Access Compliance Report Public Rights-of-Way (RR Crossings)

Intersection ID: 10025333	Main Street: E_6TH_ST	Location: N/A
ADA ID: D0C3ACE0013E	Overall Compliance: No	Severity Score: 0.0
Codes/Mitigation Info/Possible Solution		Field Measurements/Component Compliance

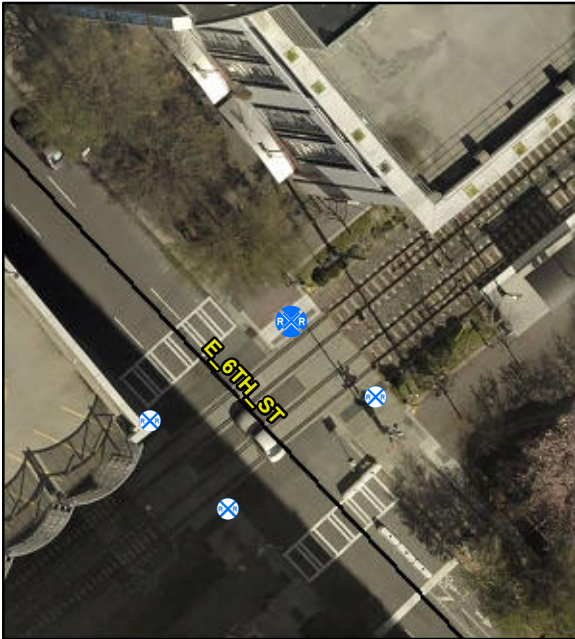
Compliance	Description	Data
Yes	DWS Provided?	Yes
Yes	DWS Contrast?	Yes
Yes	DWS Width (in)	Yes
Yes	DWS Length (in)	47.0
No	DWS Offset (in)	30.0
No	Pedestrian Gate?	No
N/A	DWS Outside Gate?	N/A
N/A	Rail Type?	LightRail
No	Flangeway Gap (in)	2.5
Yes	Sidewalk Width (in)	194.0

**Remove & Replace Detectable
Warning System. Provide Pedestrian
Gate. Remove & Replace Walking
Surface Adjacent to Rail.**
